ADDENDUM NO. 2

THIS ADDENDUM FORMS A PART OF THE CONTRACT DOCUMENTS AND HEREBY MODIFIES THE ORIGINAL CONSTRUCTION DOCUMENTS DATED MARCH 18, 2021 RESPECTIVELY.

PROJECT MANUAL

Electrical Floor Plan
Power Systems

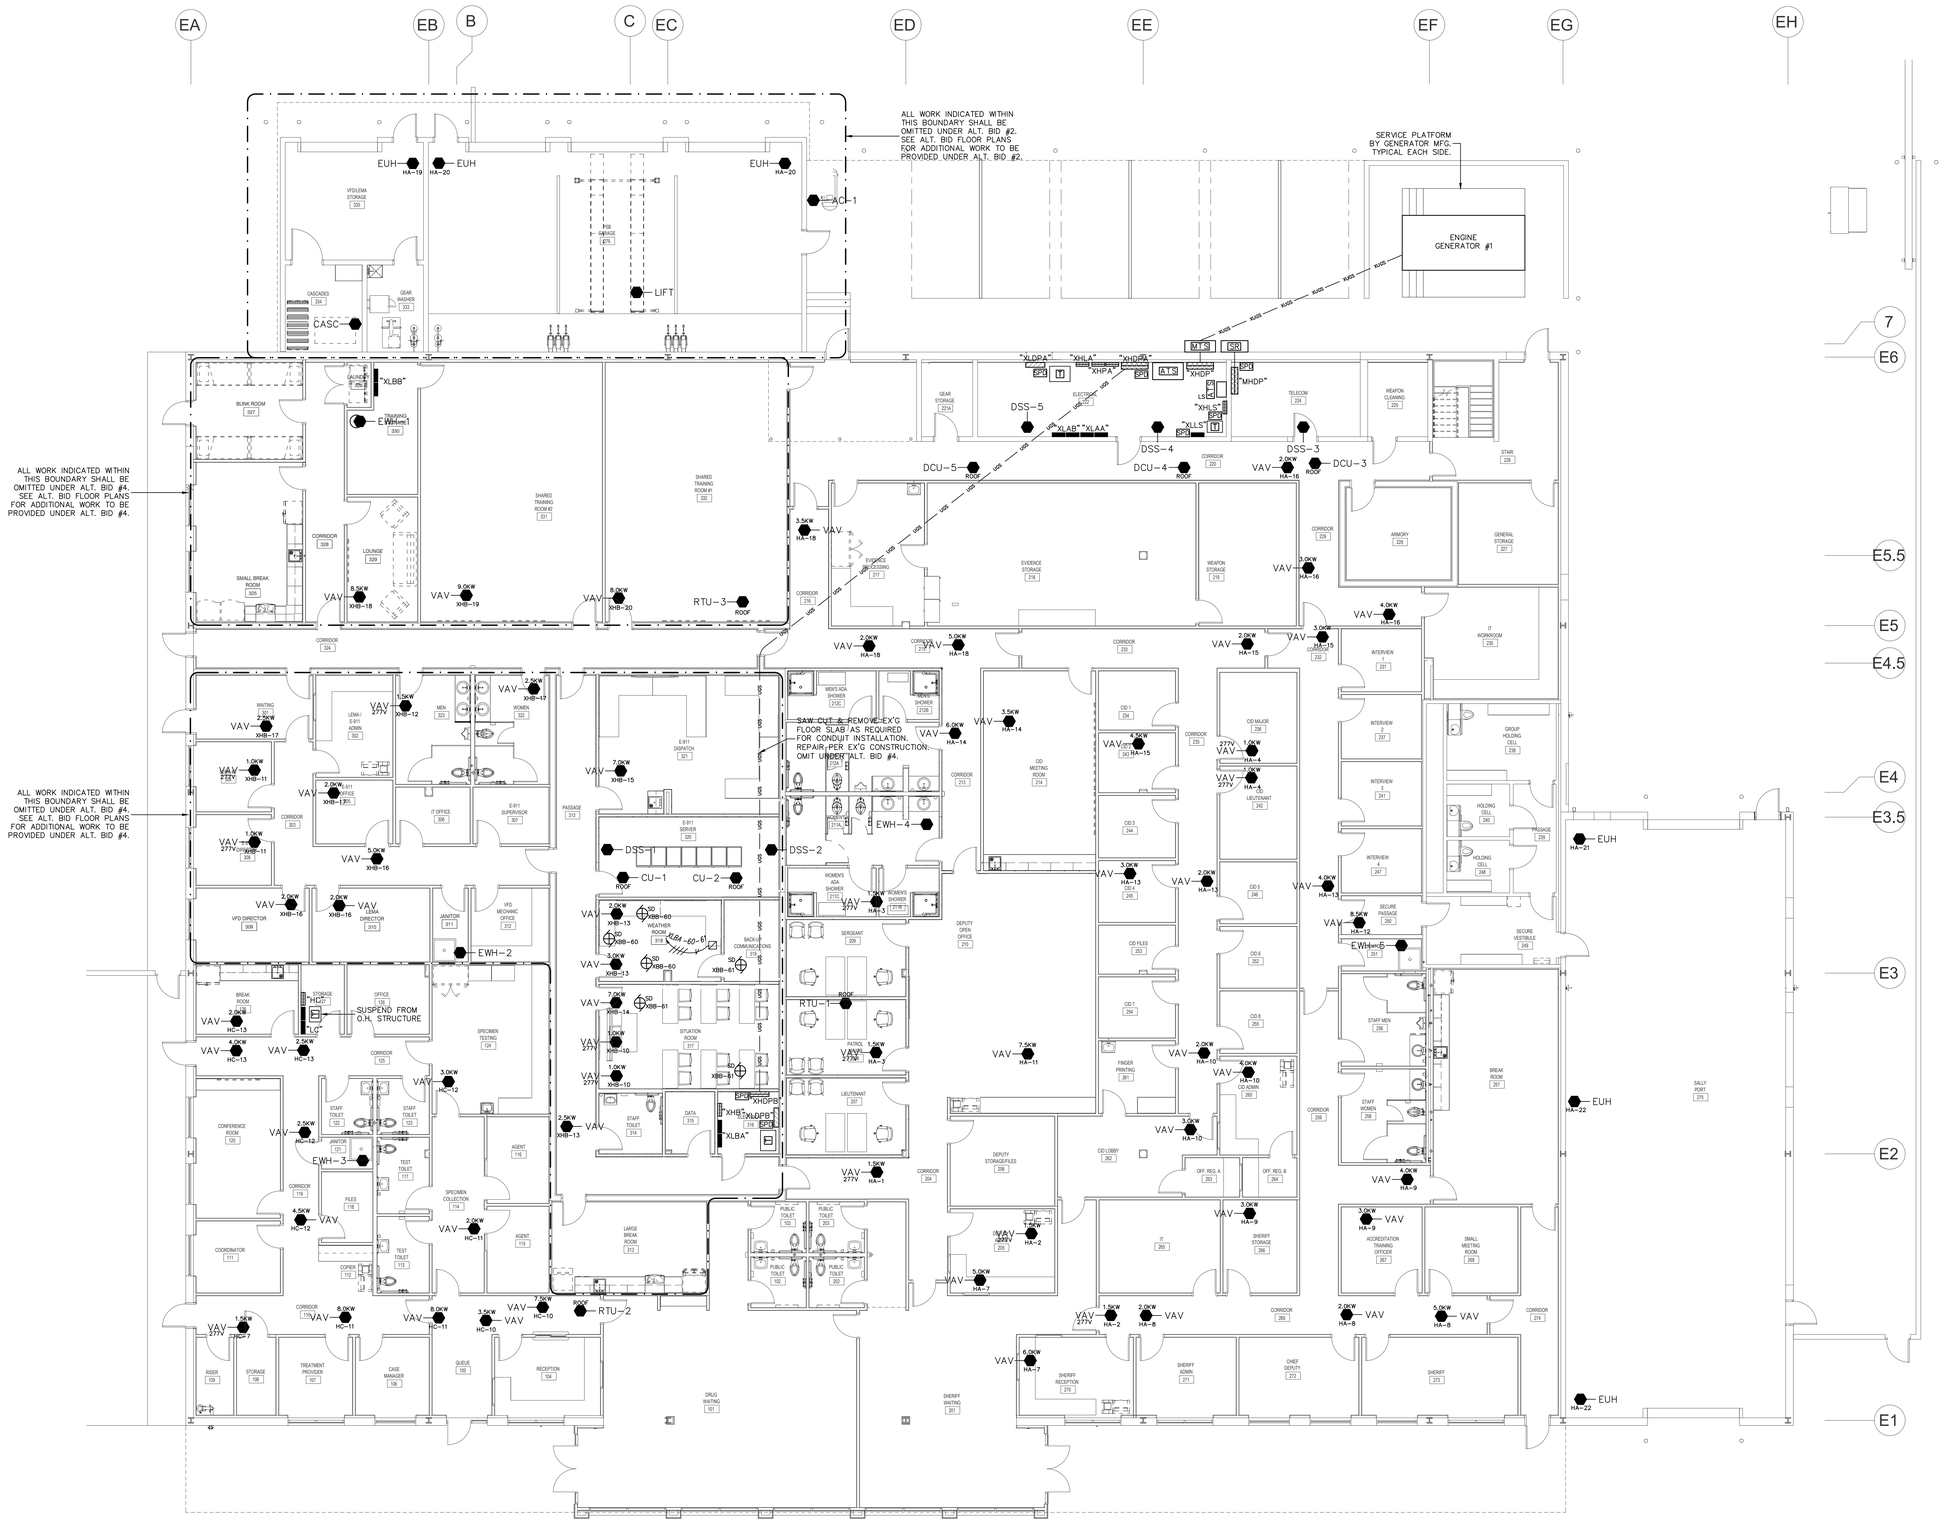
d. Floor plan revisions at the Sheriff's Office gang toilets/showers/locker rooms.

e. Floor plan revisions at the Sheriff's Office main electrical rooms and telecomm. room.

POWER & SPECIAL SYSTEMS

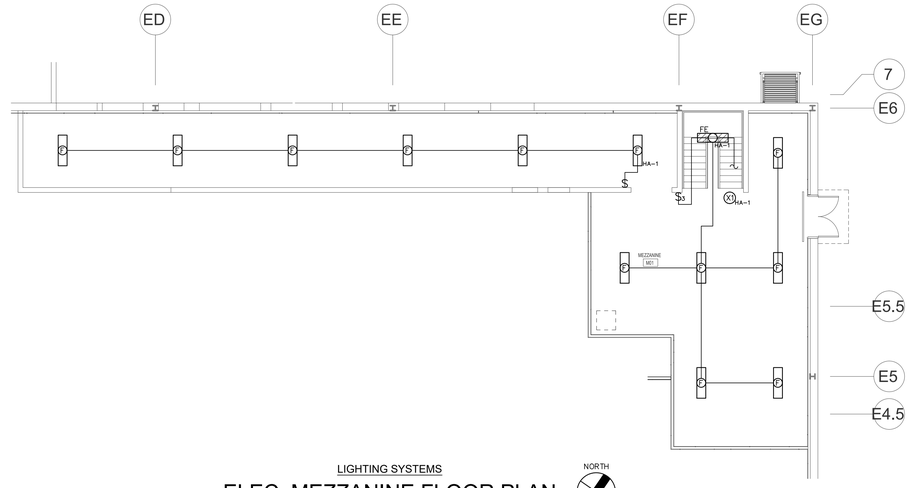
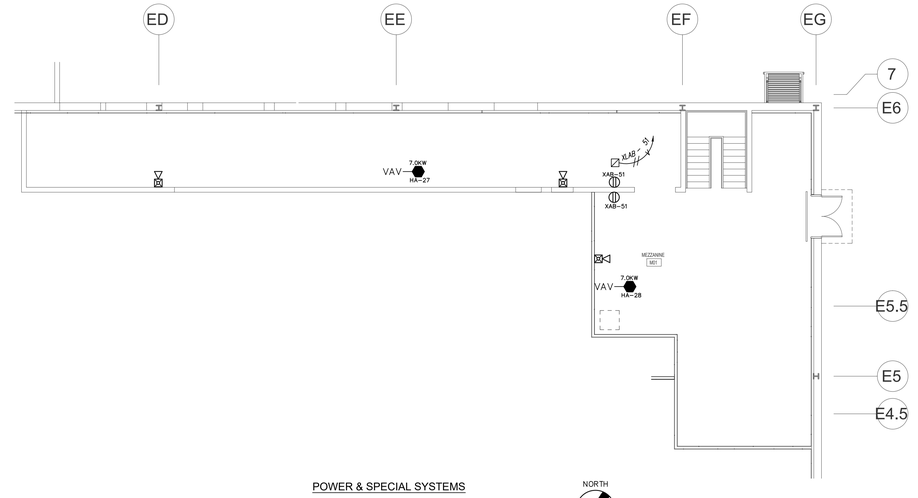
f. Defined boundary lines for Alternate Bid #2 and Alternate Bid #4. Alternate Bid floor plan, site plan and supplemental drawings to be issued in a following Addendum.

EA
EB
B
C
EC
ED
EE
EF
EG
EH
7
E6
E5.5
E5
E4.5
E4
E3.5
E3
E2
E1
ALL WORK INDICATED WITHIN THIS BOUNDARY SHALL BE OMITTED UNDER ALT. BID #2. SEE ALT. BID FLOOR PLANS FOR ADDITIONAL WORK TO BE PROVIDED UNDER ALT. BID #2.
ALL WORK INDICATED WITHIN THIS BOUNDARY SHALL BE OMITTED UNDER ALT. BID #4. SEE ALT. BID FLOOR PLANS FOR ADDITIONAL WORK TO BE PROVIDED UNDER ALT. BID #4.
ALL WORK INDICATED WITHIN THIS BOUNDARY SHALL BE OMITTED UNDER ALT. BID #4. SEE ALT. BID FLOOR PLANS FOR ADDITIONAL WORK TO BE PROVIDED UNDER ALT. BID #4.
FOR INTERFACE W/HOOD FIRE SUPPRESSION SYS.
FOR INTERFACE WITH FIRE SUPPRESSION SYS.
FOR INTERFACE W/HOOD FIRE SUPPRESSION SYS.
RTU-3
RTU-1
RTU-2
VEST/ENTRANCE 100
PSB GARAGE 175
CASCADE
GEAR
LAUNDRY 326
BUNK ROOM
TRAINING STORAGE 330
CORRIDOR 328
LOUNGE 329
SMALL BREAK ROOM 325
SHARED TRAINING ROOM #2 331
SHARED TRAINING ROOM #1 332
GEAR STORAGE 221A
ELECTRICAL 222
TELECOM 224
WEAPON CLEANING 225
CORRIDOR 220
STAIR 226

ELECTRICAL SERVICE & DISTRIBUTION SYSTEMS

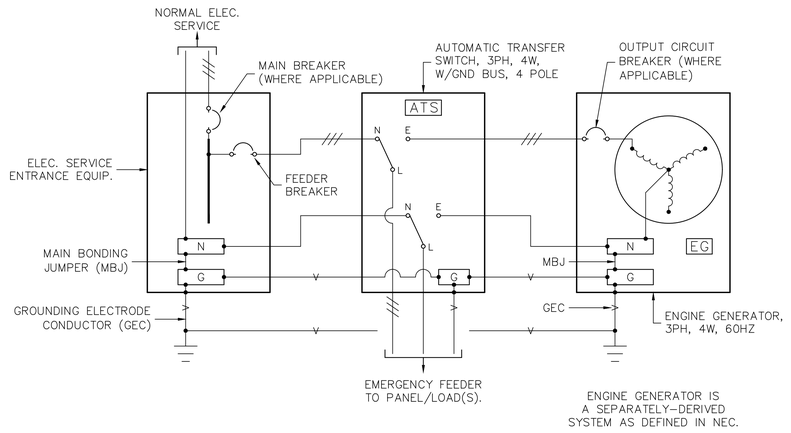
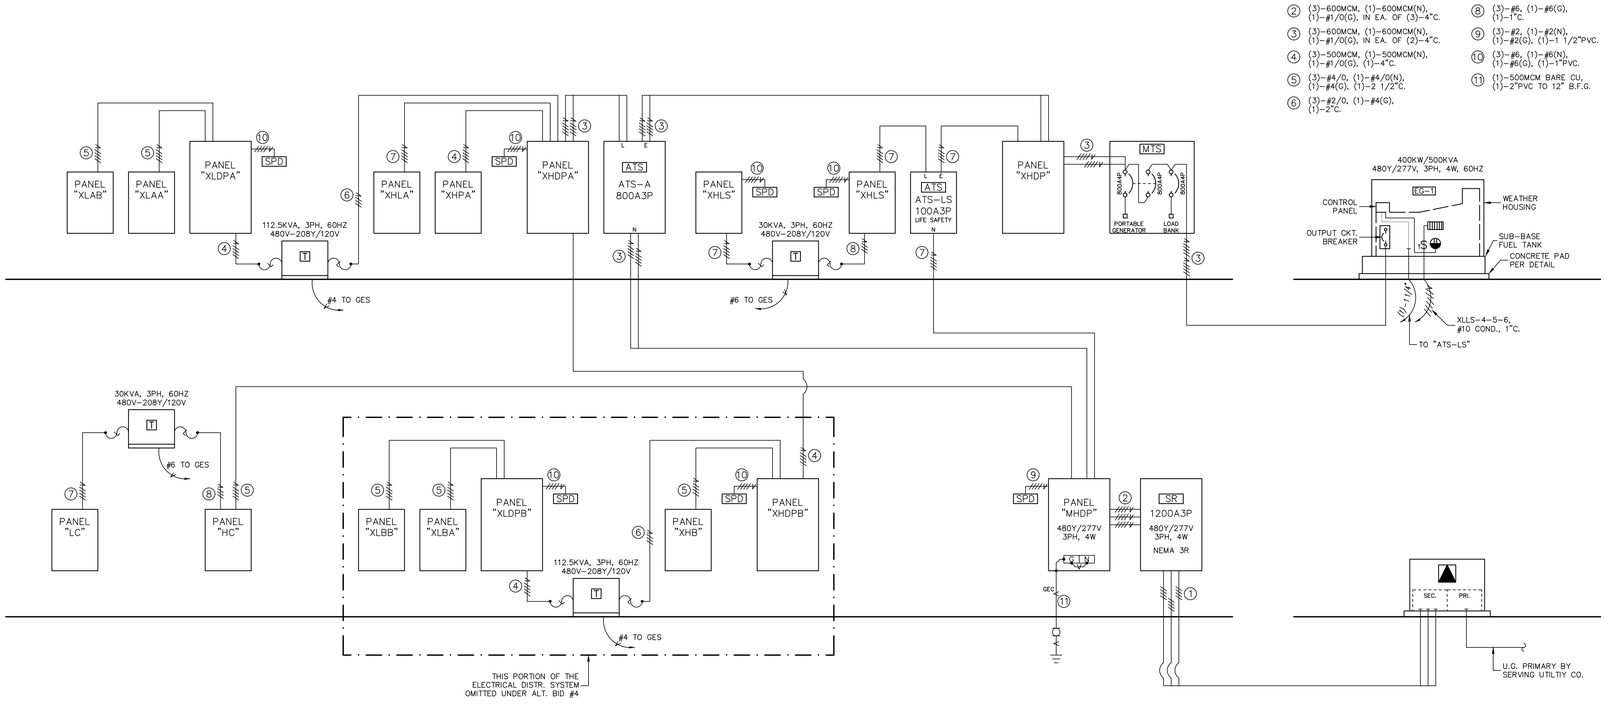
b. Added 3-Way Tripleswitch Manual Transfer Switch and Panelboard "XHDP" to the emergency power service.

c. Added maintenance platforms to Engine Generator #1.
